**Model
Administrative Change Notice**

1. Document Number:	ANL-EBS-MD-000004	2. Revision:	02	3. ACN:	01
4. Title:	General Corrosion and Localized Corrosion of the Drip Shield				
5. No. of Pages Attached	+ 3 <i>MS</i> 4/26/06

Figure 4. Waste Package Temperature and Relative Humidity Ranges

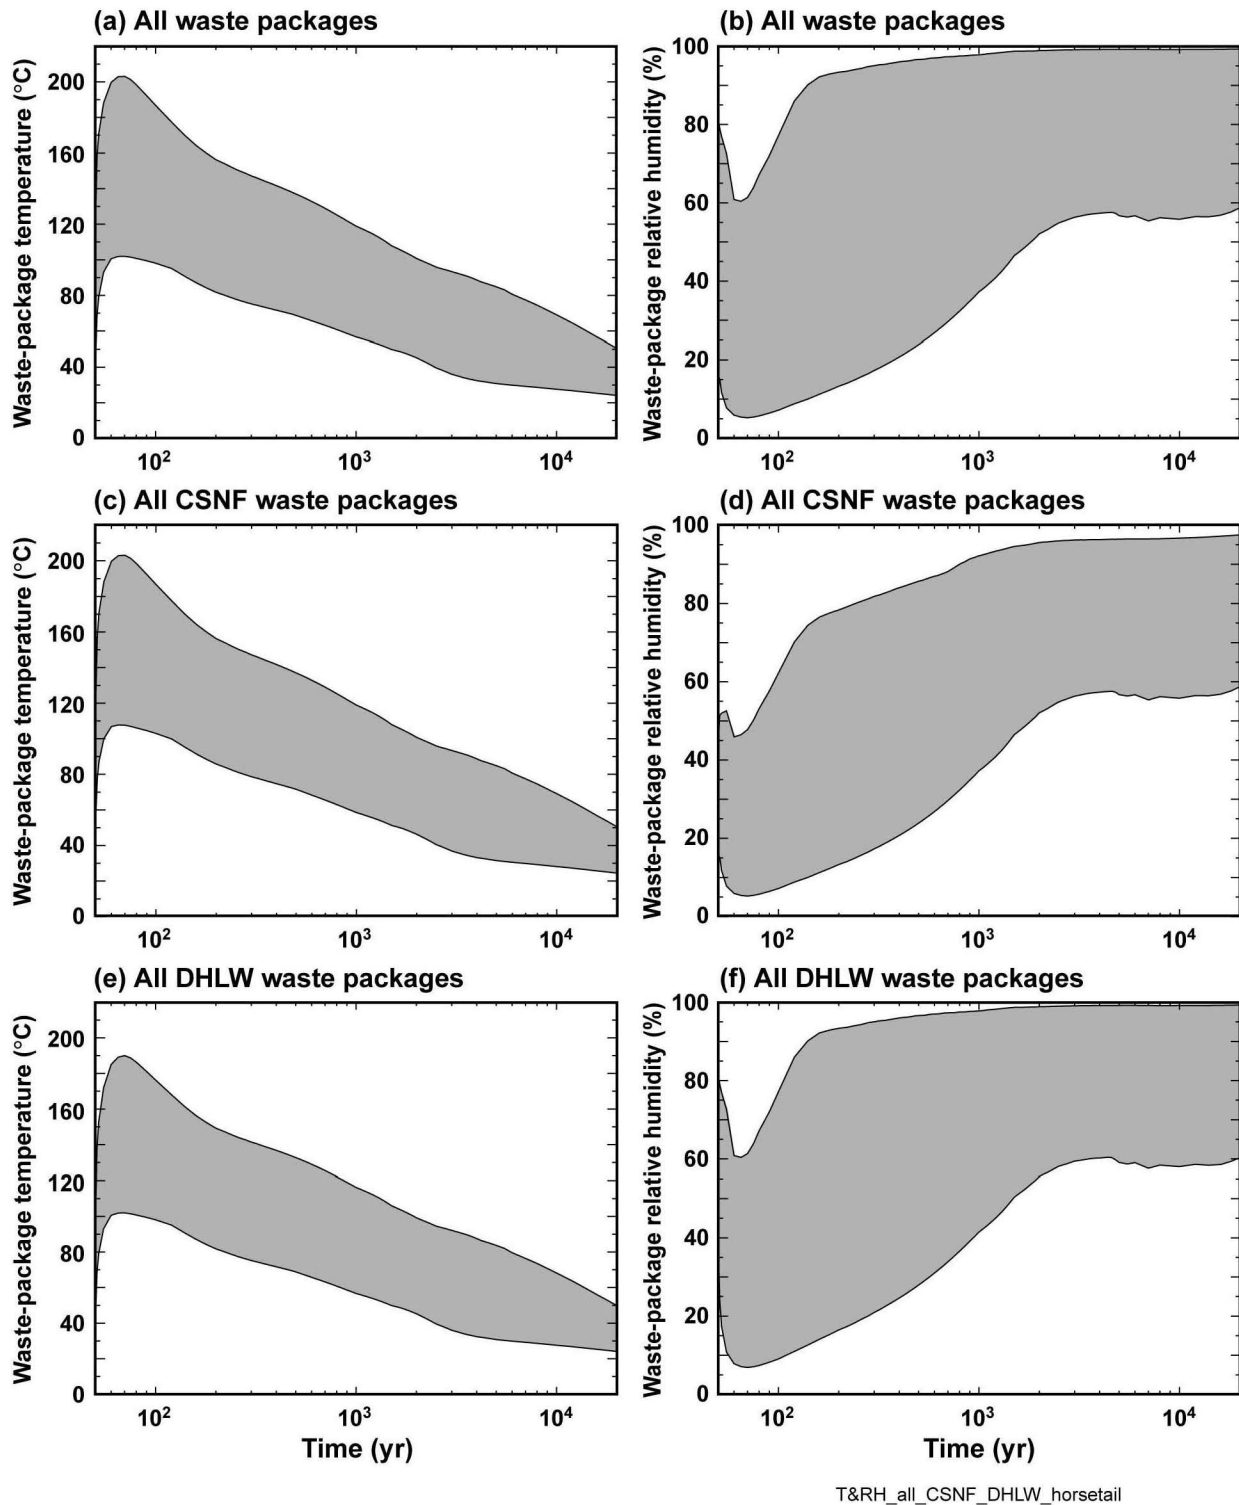
7. Affected Pages	8. Description of Change:
6-4	Replace Figure 4. Waste Package Temperature and Relative Humidity Ranges with correct figure (BSC 2004 [DIRS 169565], Figure 6.3-53). Change due to CR 7272 and TBV-5983
6-36 and 6-39	Additional text added to clarify the use of DTN LL990610605924.079. This does not affect the input values or results. Change due to CR 6664, Action 6664-004
